*Revision updating drainage areas and inlet calculations and utility main alignments

CORLEY FARMS
UNIT 2

CONSTRUCTION PLANS

WATER DISTRIBUTION PLAN

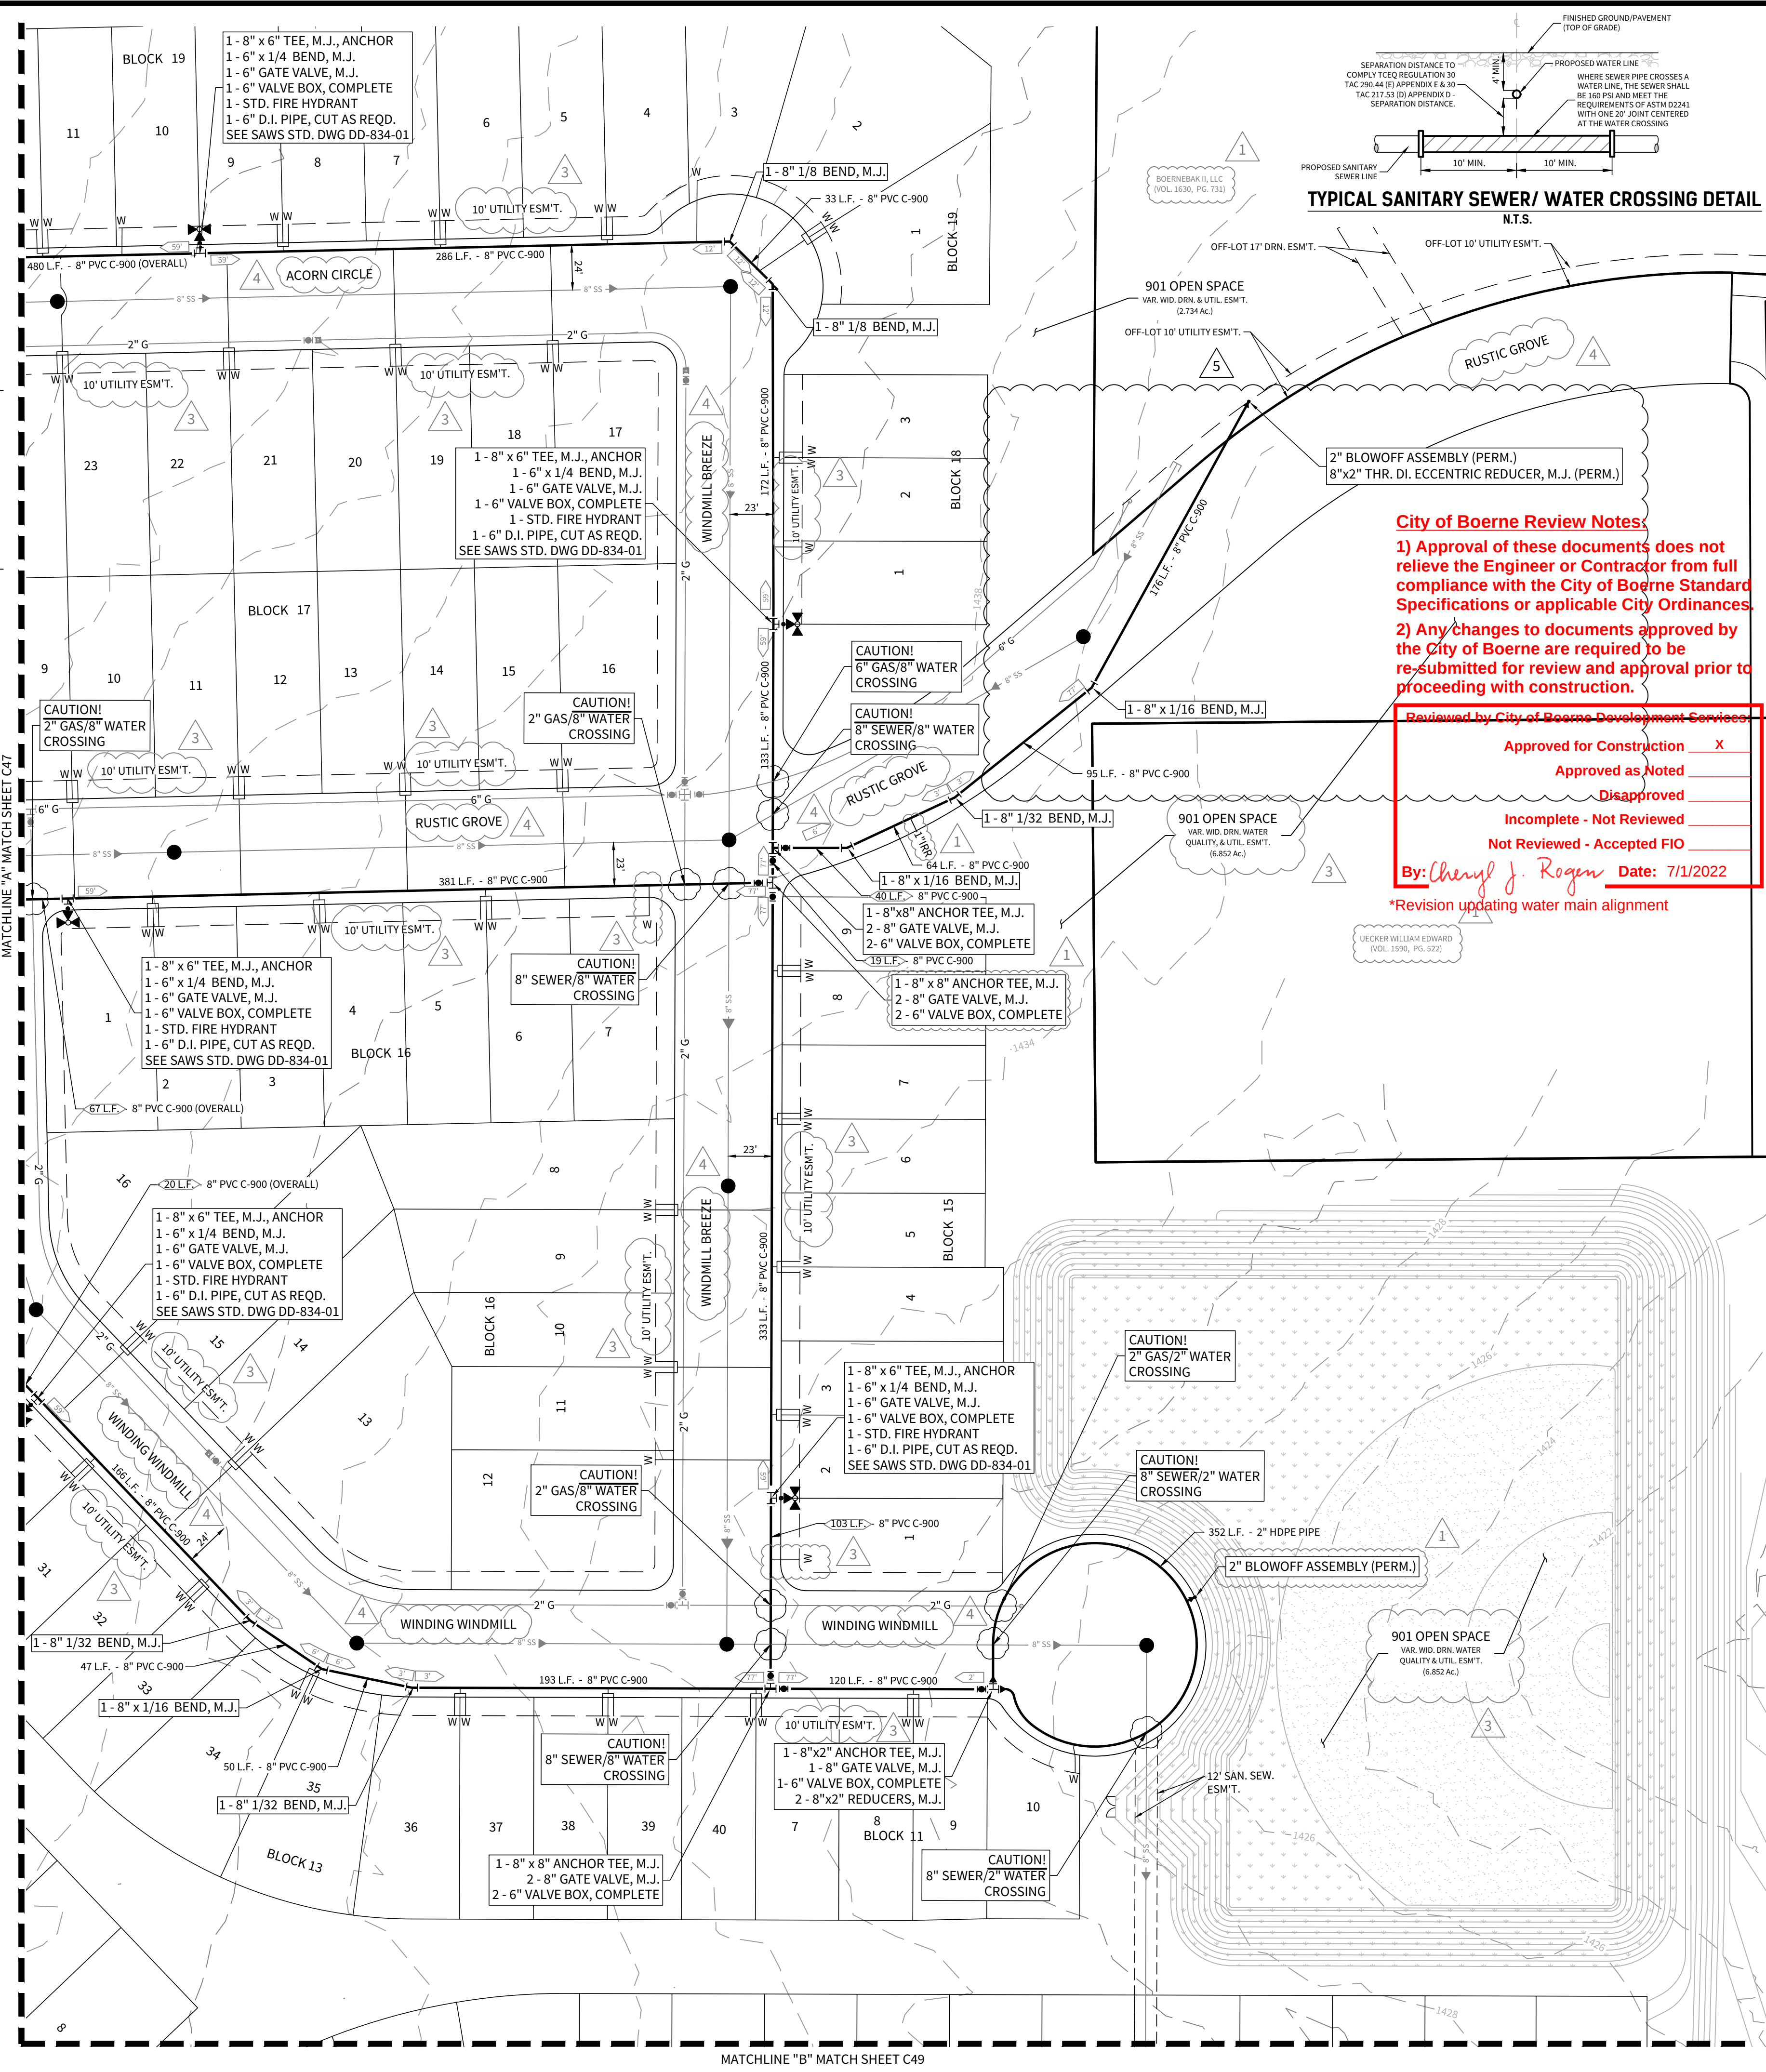
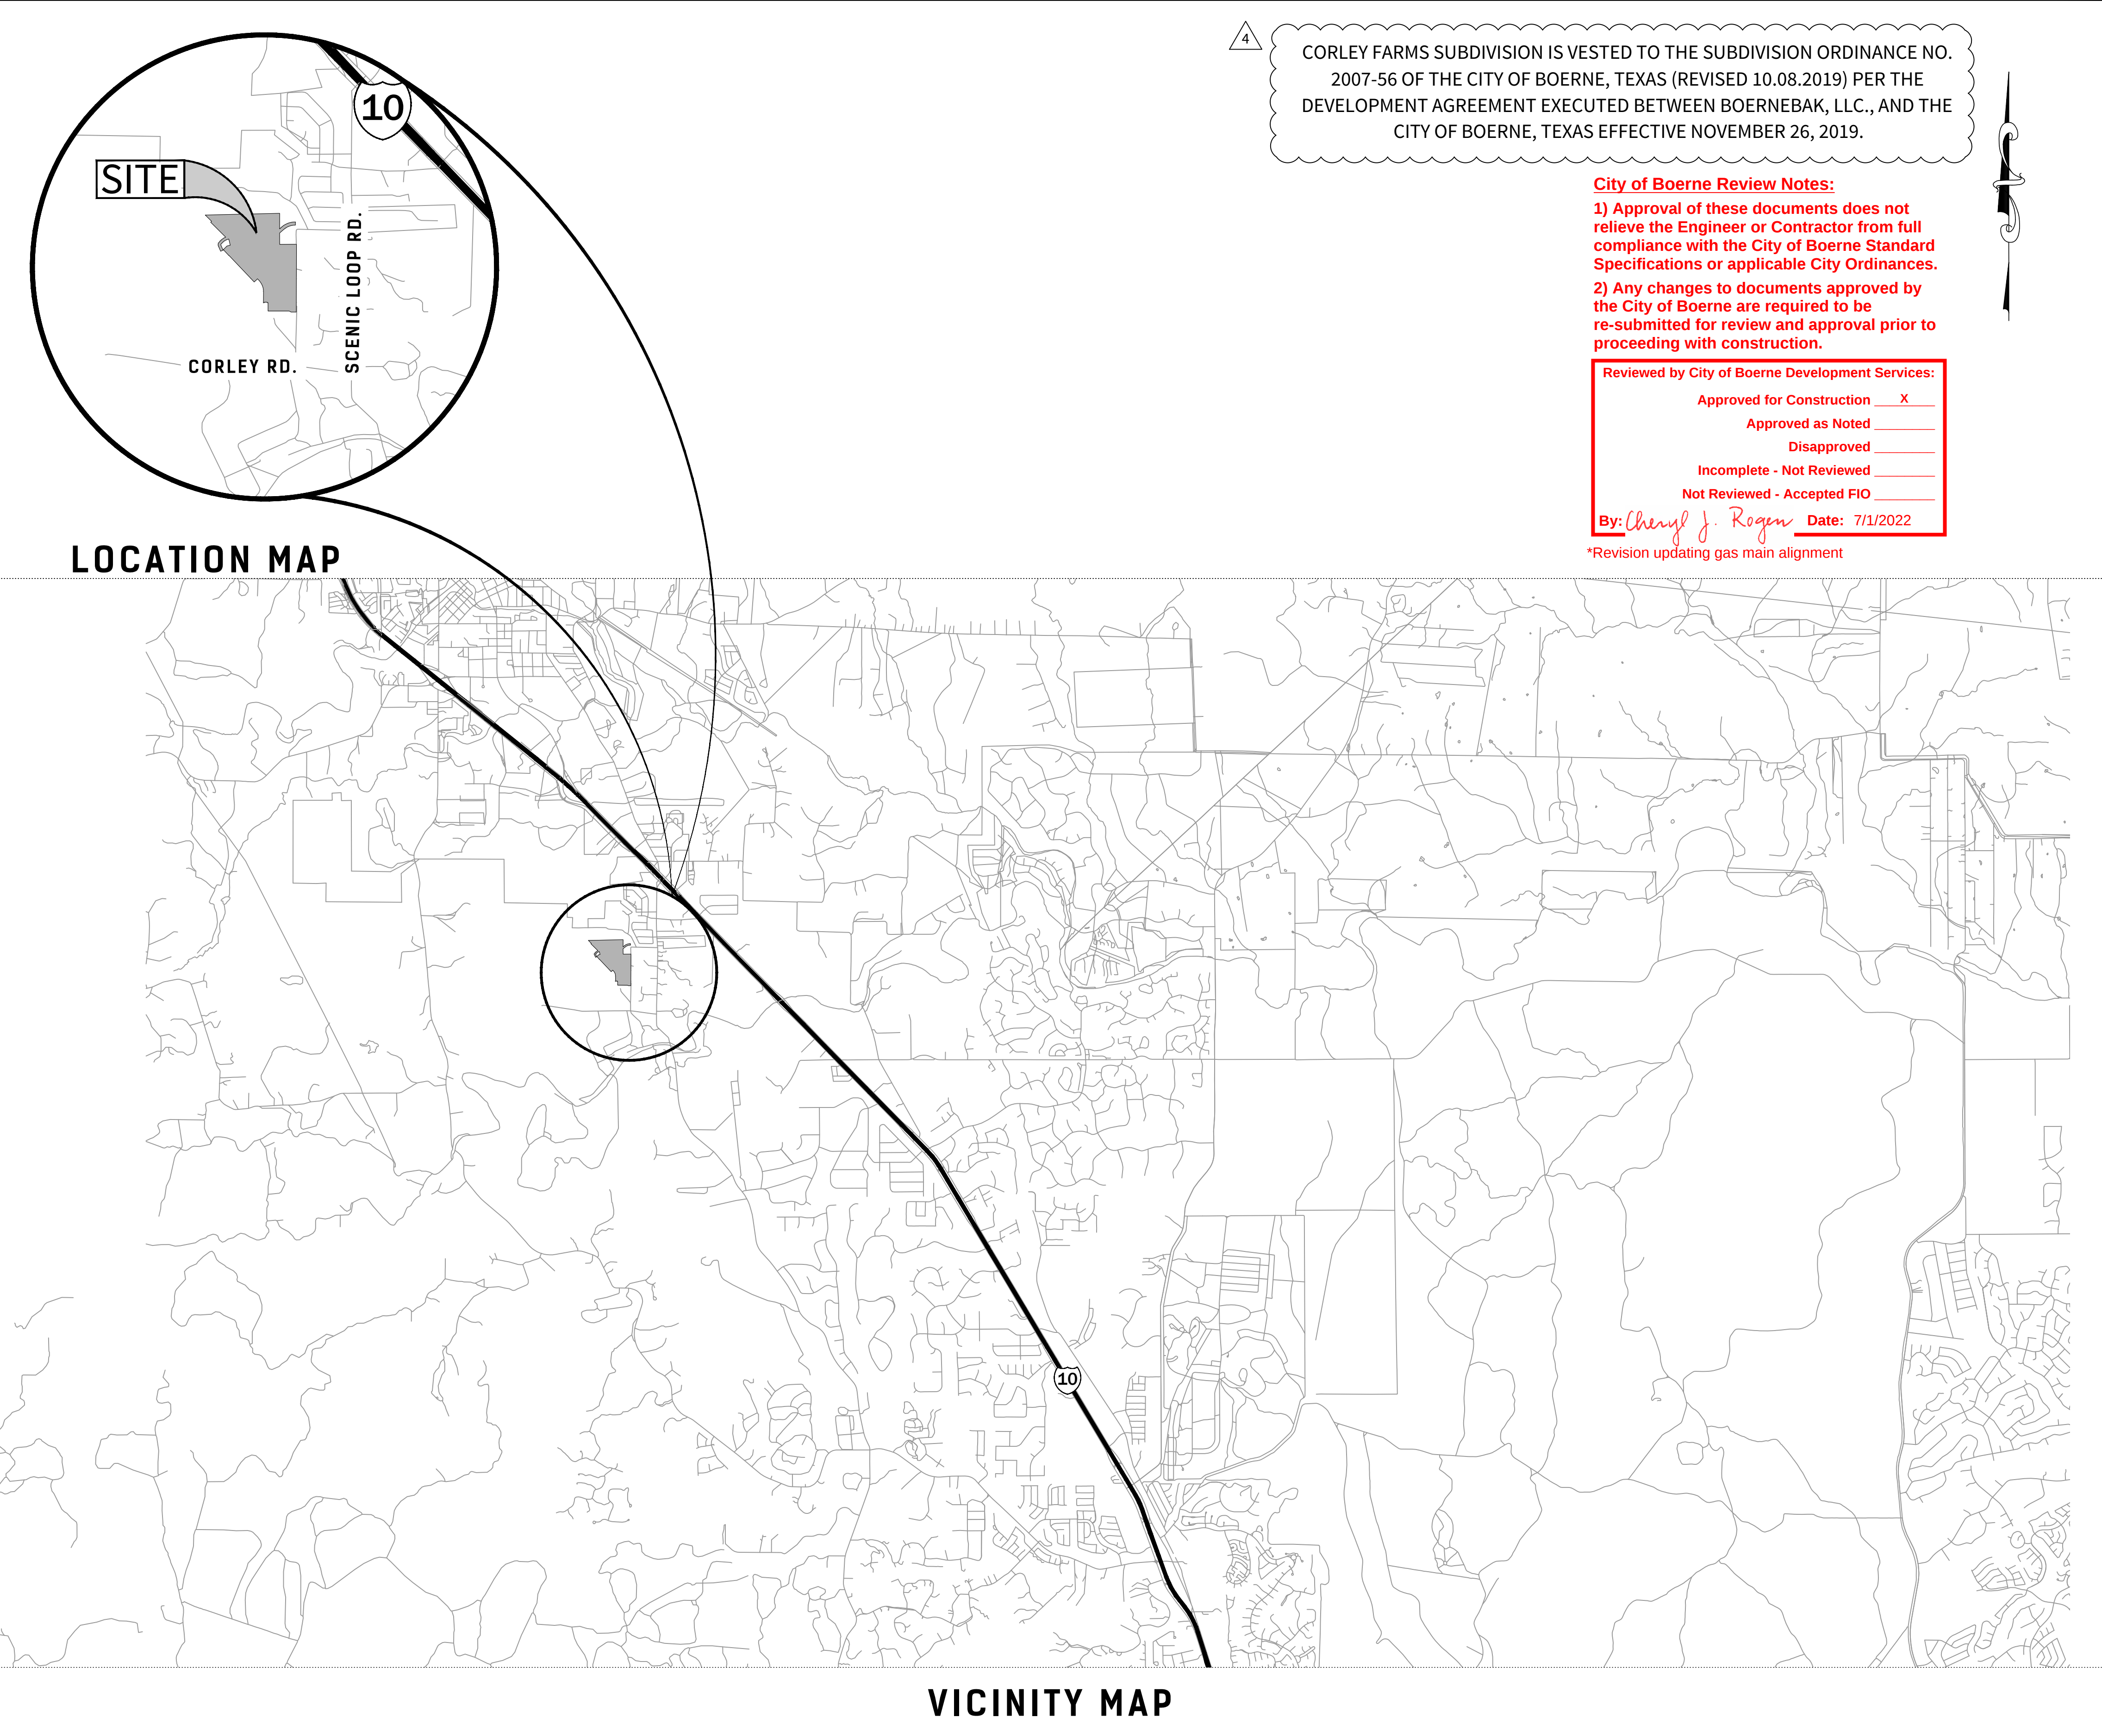
City of Boerne Review Notes:
1) Approval of these documents does not relieve the Engineer or Contractor from full compliance with the City of Boerne Standard Specifications or applicable City Ordinances.
2) Any changes to documents approved by the City of Boerne are required to be re-submitted for review and approval prior to proceeding with construction.
Reviewed by City of Boerne Development Services
Approved for Construction ☒ X
Approved as Noted ☐
Disapproved ☐
Incomplete - Not Reviewed ☐
Not Reviewed - Accepted FIO ☐
By: Cheryl J. Rogan Date: 7/1/2022
*Revision updating water main alignment

DATE	03/03/2022
PROJECT NO.	03481.005
DRAWN BY	C3
CHECKED BY	JV/JC/DCC
REVISIONS	1. 2021-06-30 - SAWS COMMENTS 2. 3. 2021-10-07 - CITY OF BOERNE COMMENTS 4. 2021-11-12 - ADDED STREET NAMES 5. 2022-03-04 - WATER MAIN EXTENSION 6. 7. 8. 9.
